Interconnection Facilities Study Report

Request # GI-2006-2

Peetz Logan Interconnect, LLC.
200 MW Expansion
Facility Study

Response to Xcel Energy's Draft Interconnection Facilities Study of Peetz Logan 200 MW expansion dated September 20, 2007

P21-22 – Computer modeled plots demonstrating system parameters with and without the addition of a 200 MVAR capacitor

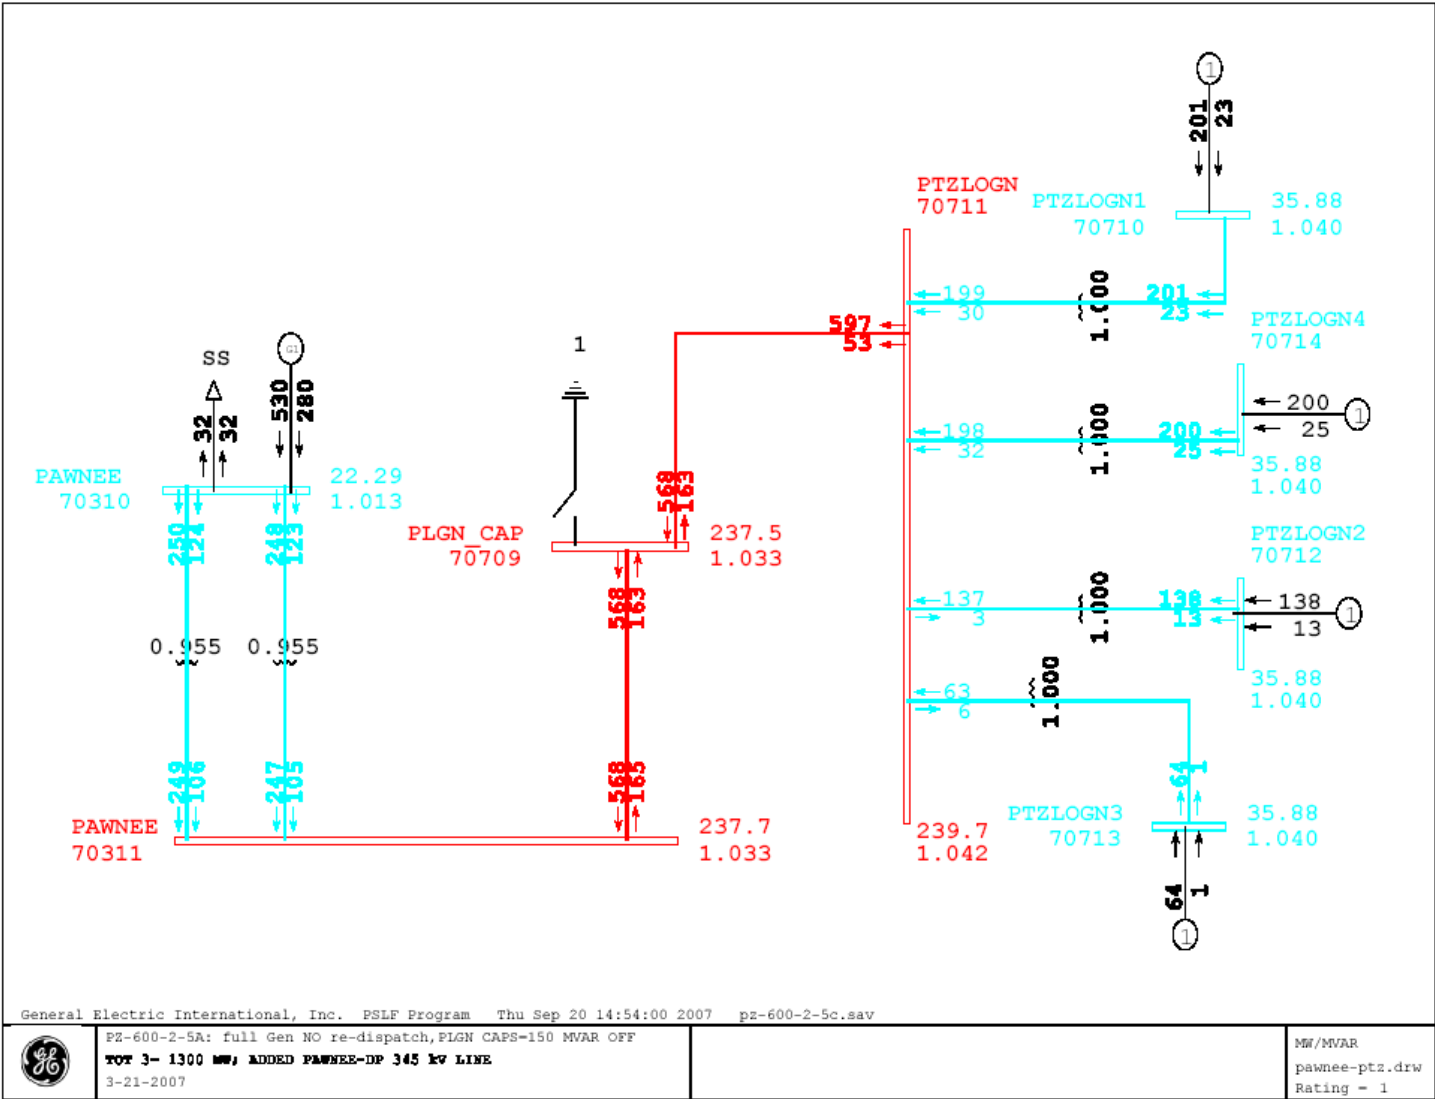
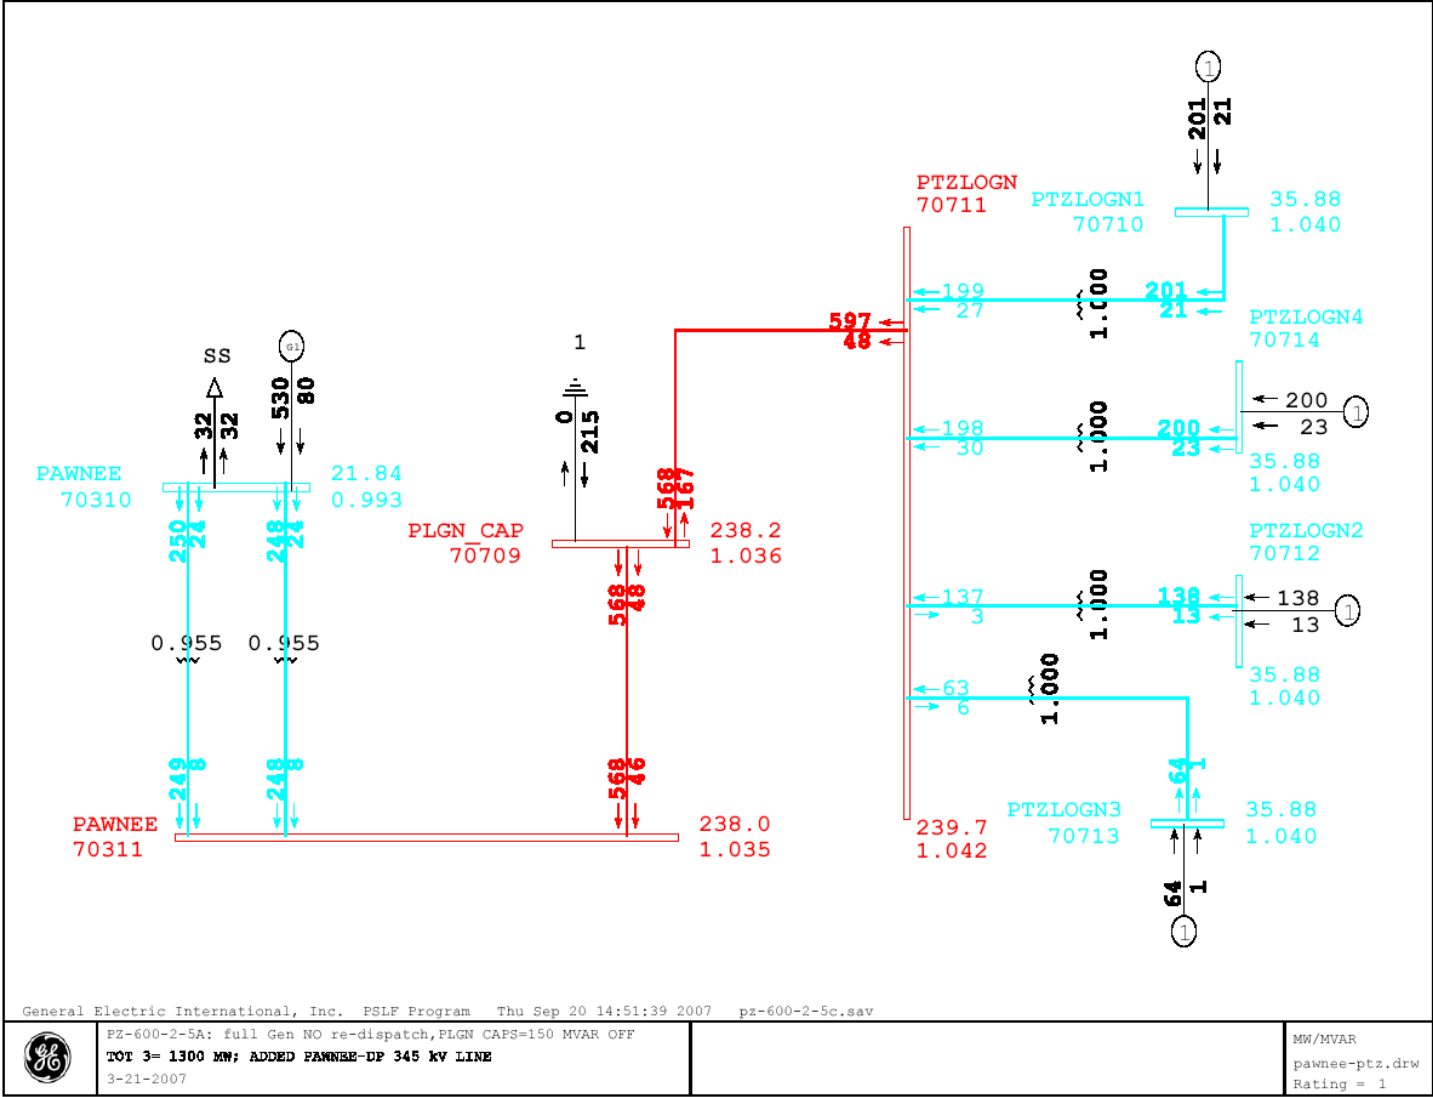
Issue: This shows the effect on the reactive reserves of the Pawnee plant with and without the capacitor. However, it does not include a demonstration of a reliability violation.

Reasoning: The FERC LGIP requires that the TP demonstrate a reliability or safety violation in order to justify upgrades and/or new facilities. Please also refer to the notes above.

PSCo will discuss these comments with the customer during the LGIA contract negotiations.
